# UNITED STATES PATENT AND TRADEMARK OFFICE

10/553,973

<b>Office Action Summary</b>	<b>Application No.</b> 10/553,973	<b>Applicant(s)</b> GAZZA, GIANLUCA	
	<b>Examiner</b> DIANNE DORNBUSCH	<b>Art Unit</b> 3773

## DETAILED ACTION

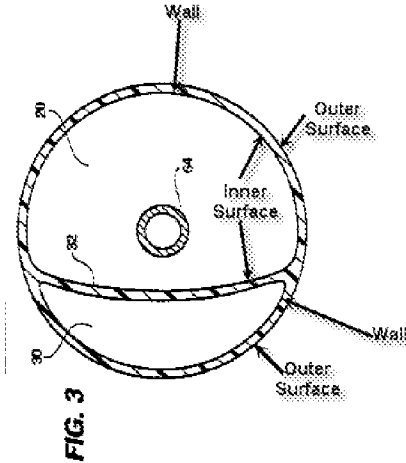
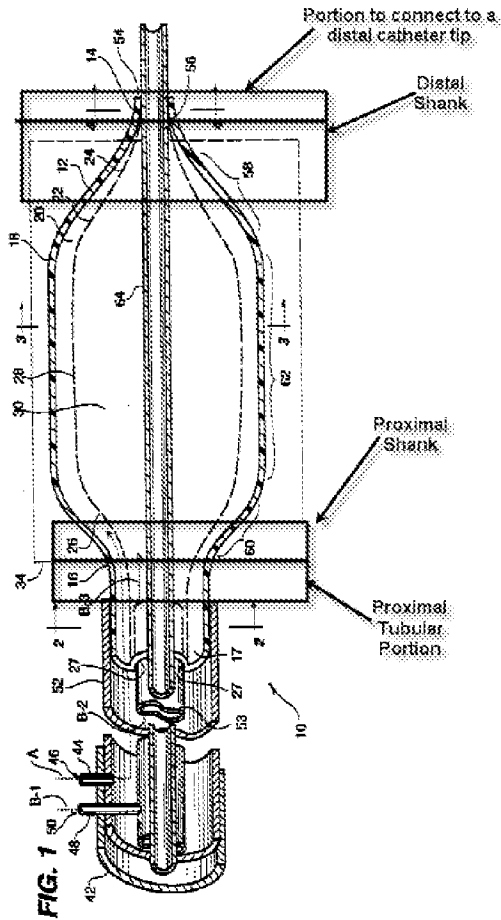
Claim 74: That the wall cavity is within the wall which delimits the inflation chamber for the whole of its extent which affects the balloon structure (see figure below).

Claim 78: That the balloon comprises a proximal tubular portion (see figure below) in the vicinity of the proximal end (see figure below).

Claim 79: That the balloon comprises a proximal shank (see figure below) connecting the proximal tubular portion and an intermediate portion (see figure below).

Claim 81: That the balloon comprises a distal connecting shank (see figure below) between the intermediate portion and a portion for connection to a distal catheter tip (see figure below).

Claim 84: That the cavity is separated from the outer surface by an external portion of the wall (see figure below).
